**MONTGOMERY COUNTY HISTORIC PRESERVATION COMMISSION**  
**STAFF REPORT**

<b>Address:</b>	21 Quincy Street, Chevy Chase	<b>Meeting Date:</b>	1/27/2021
<b>Resource:</b>	Contributing Resource <b>Chevy Chase Village Historic District</b>	<b>Report Date:</b>	1/20/2021
<b>Applicant:</b>	Andrew and Jennifer Tulumello (Wouter Boer, Architect) (Nick Reis, Landscape Architect)	<b>Public Notice:</b>	1/13/2021
		<b>Tax Credit:</b>	N/A
<b>Review:</b>	HAWP	<b>Staff:</b>	Dan Bruechert
<b>Case No:</b>	938097	<b>Tax Credit:</b>	n/a
<b>PROPOSAL:</b>	Swimming Pool, Accessory Construction, Tree Removal, and Hardscape Alteration

PROPERTY FENCE  
Scale: 1" = 1'-0"

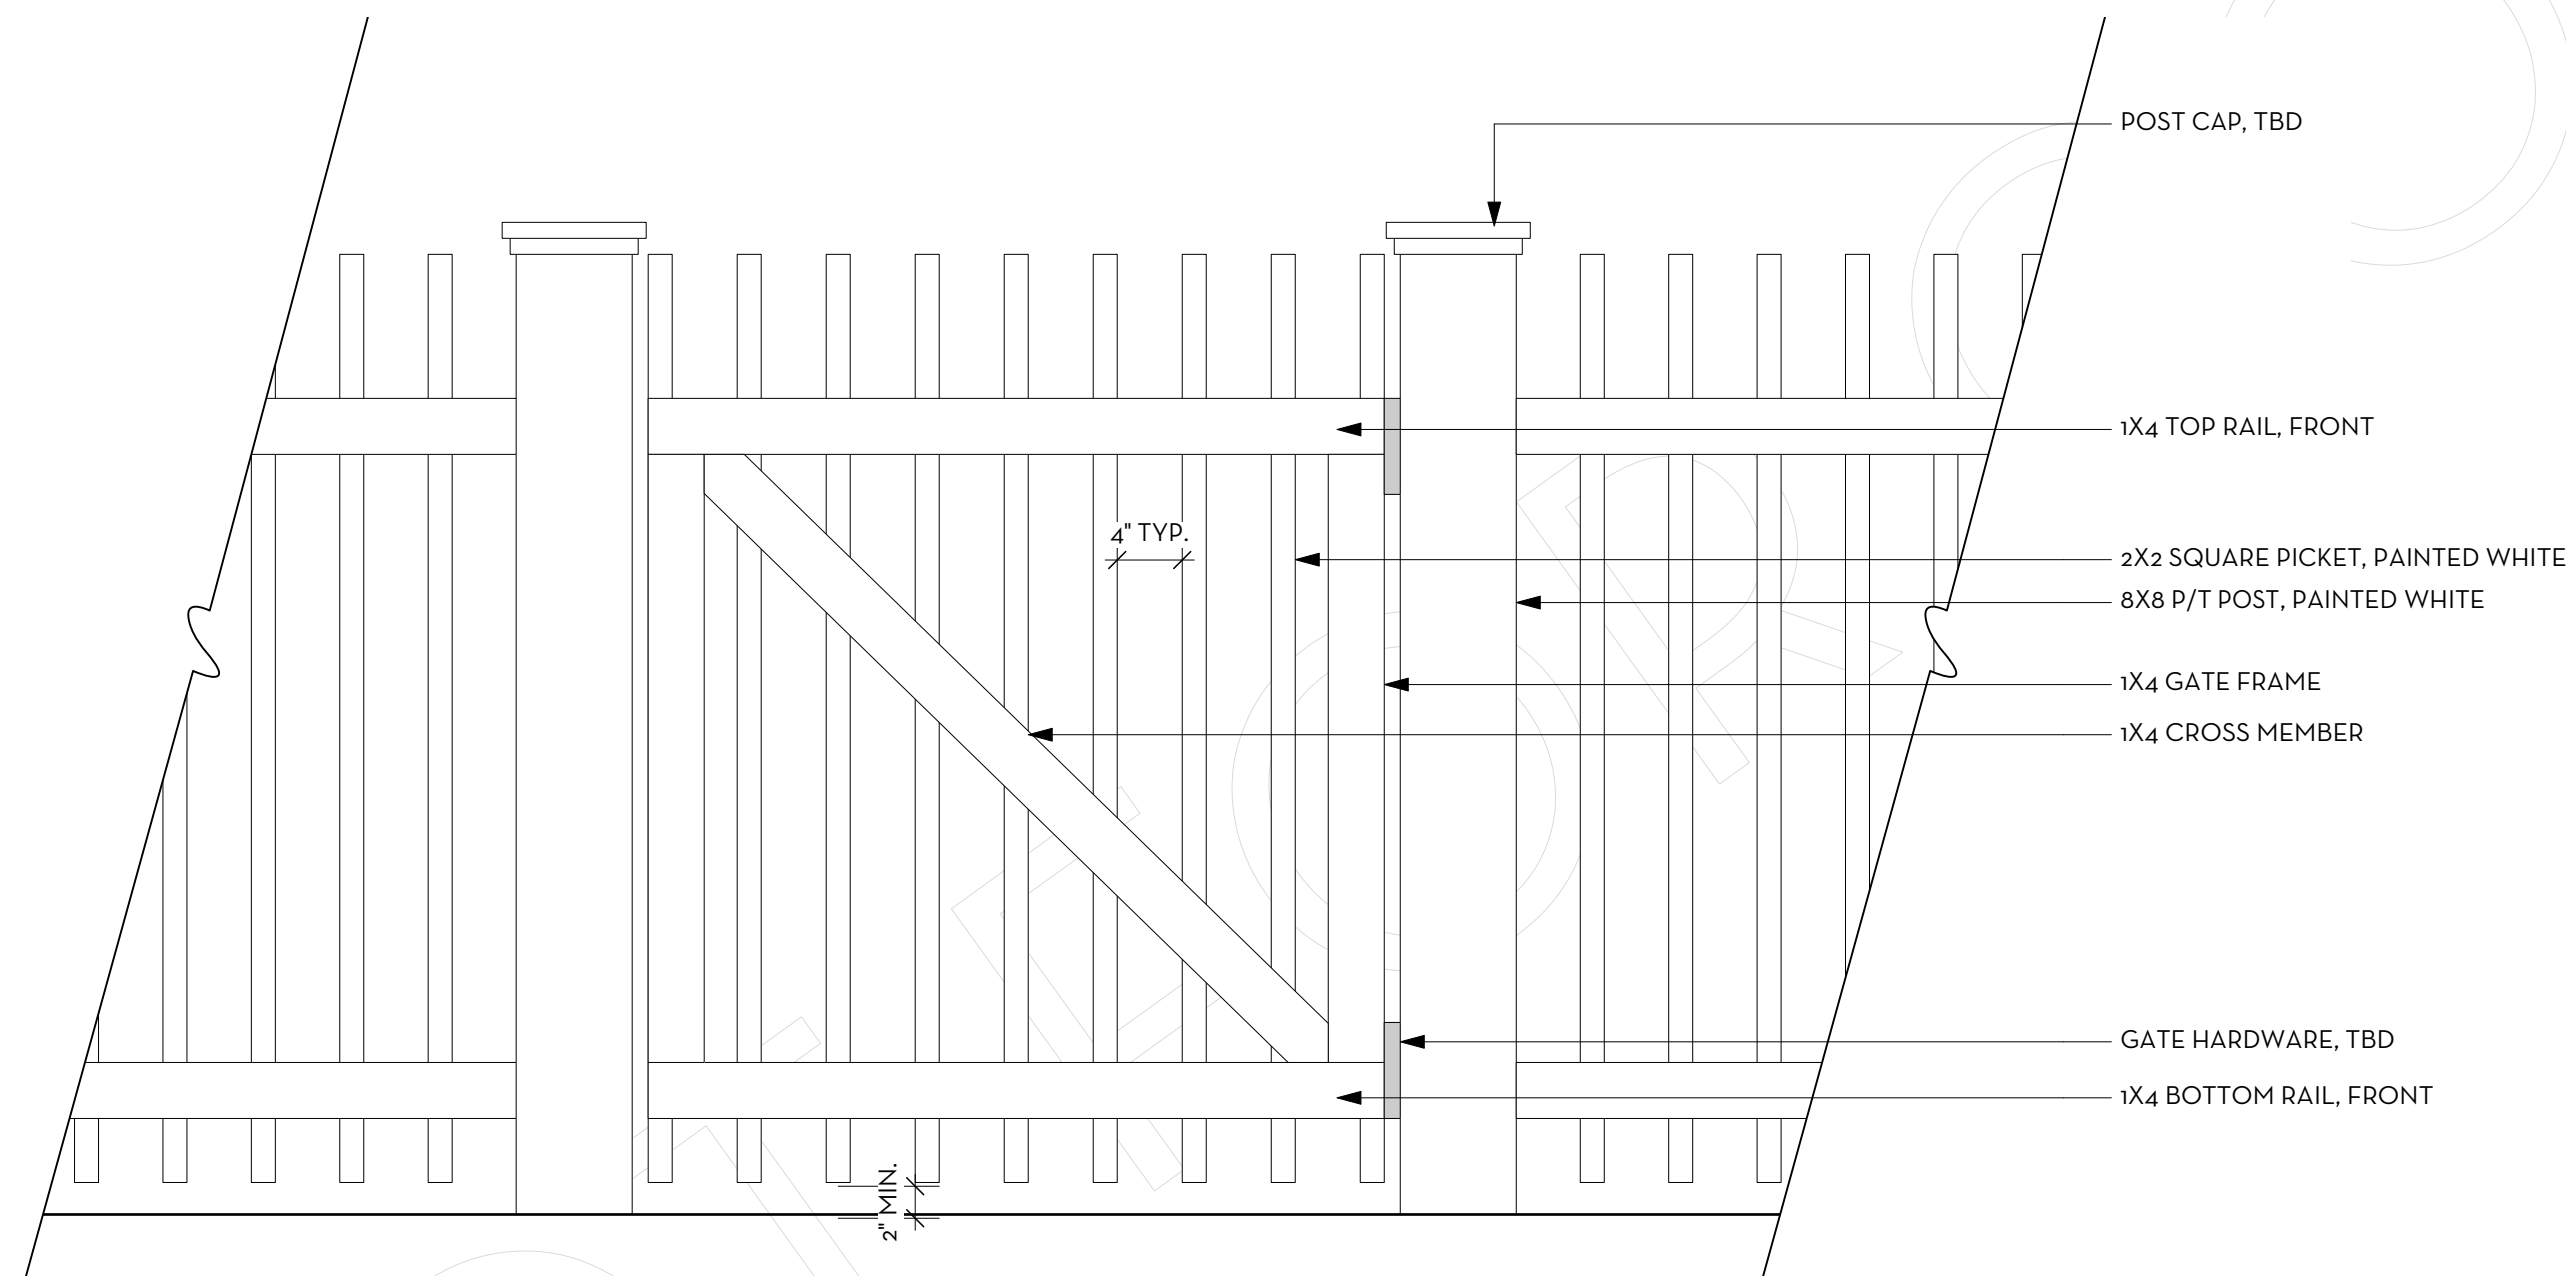
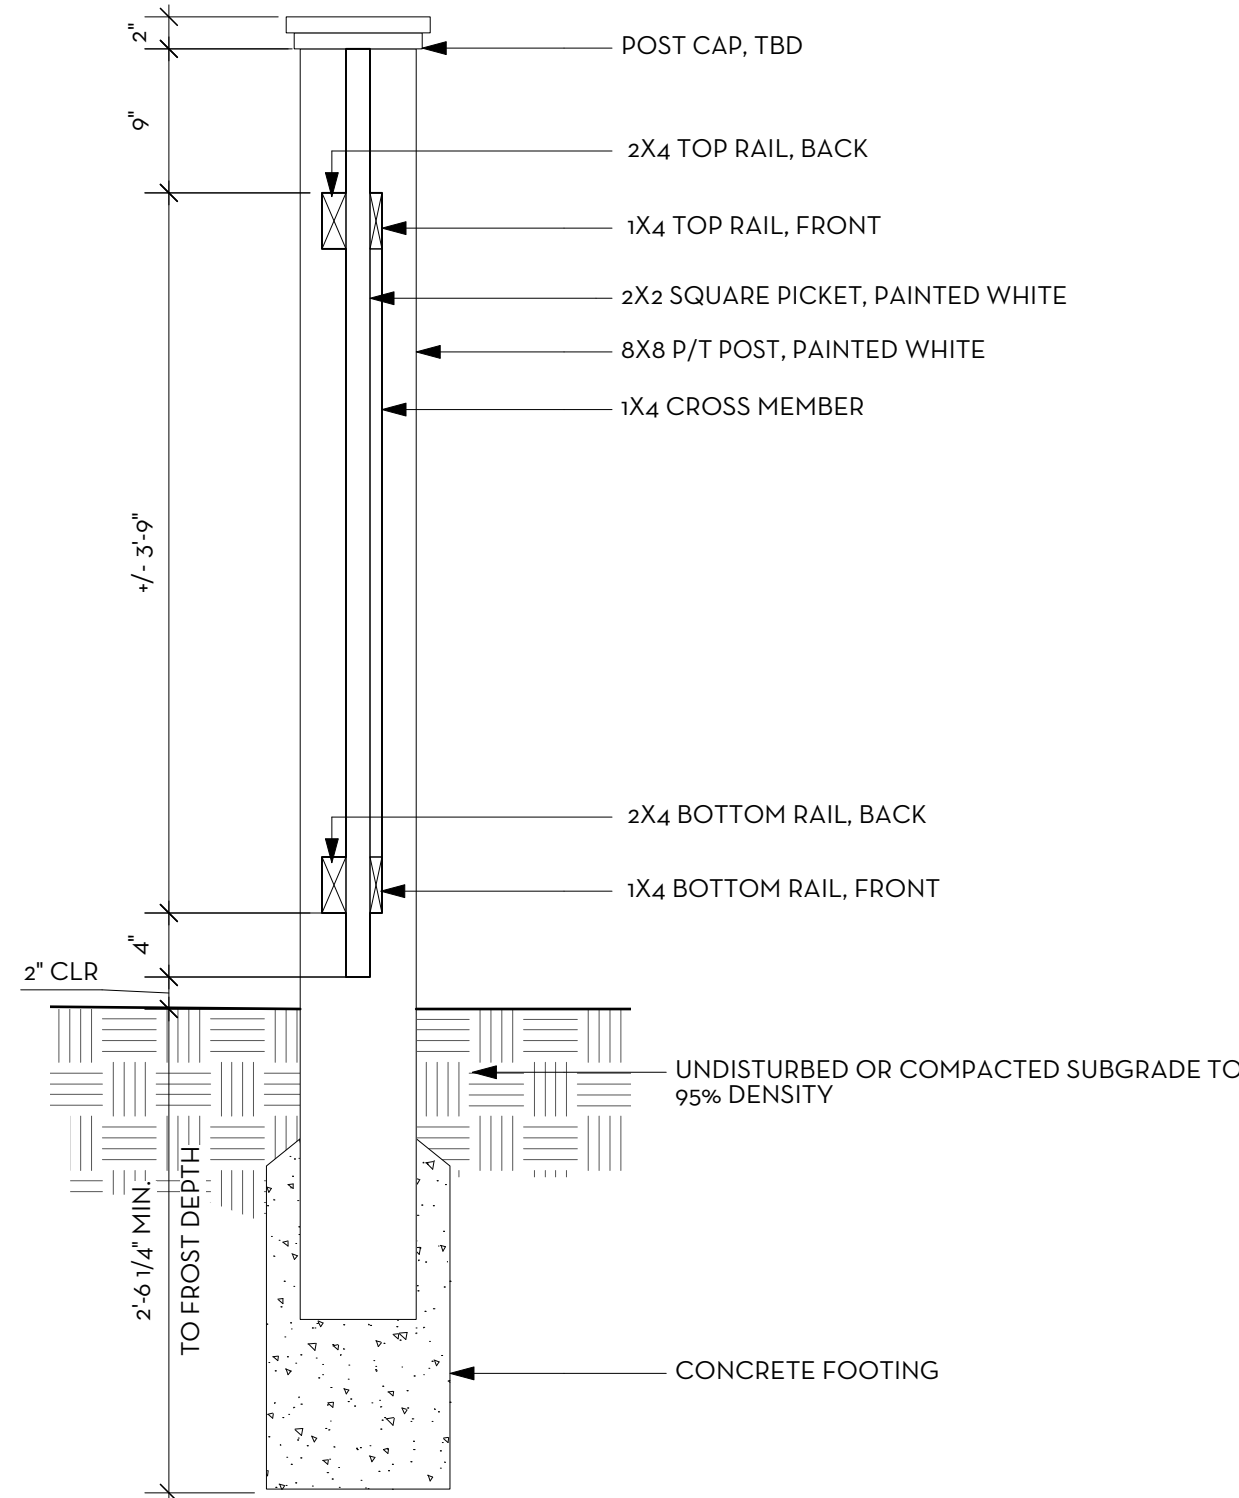
Along the front property line, the applicant proposes to install a 5' tall wood picket fence. The fence will have square pickets (2" x 2") and posts (8" x 8") and there will be a gate in front of the front entrance, another to the side yard to the right, and a paired gate at the driveway. This fence also serves as the code-required fence surrounding the swimming pool.

The HPC generally disfavors fences in front of the rear wall plane of houses within the Chevy Chase Village Historic District that exceed 48" (forty-eight inches). This height was determined to be sufficient to enclose the property while preserving the open setting of the district. Staff additionally finds the perspective drawings to be slightly deceptive because the view of the front yard is from above eye level so the impact of the fence height is reduced.

Staff finds that the materials and design are appropriate for the house and district. Staff additionally finds the placement of the fence to be appropriate. Staff's concerns about the fence creating a wall effect at the front of the property remain, however, the fence is setback from the sidewalk. The 5' (five-foot) fence height is also significant because it will serve as the fence surrounding the swimming pool, as required by code. If this fence were only 4' (four feet) tall, the applicant would need to construct a second 5' (five-foot) tall fence surrounding the pool area. A second fence on the property would likely have more of a negative effect on the open park-like setting of the district than a single, slightly taller fence at the front of the property. Staff finds that on the whole, the proposed fence compatible with the requirements under *Moderate Scrutiny* and that constructing a single fence that might be a little taller at the front is greatly preferable to constructing two fences. Staff recommends approval of the proposed fence.
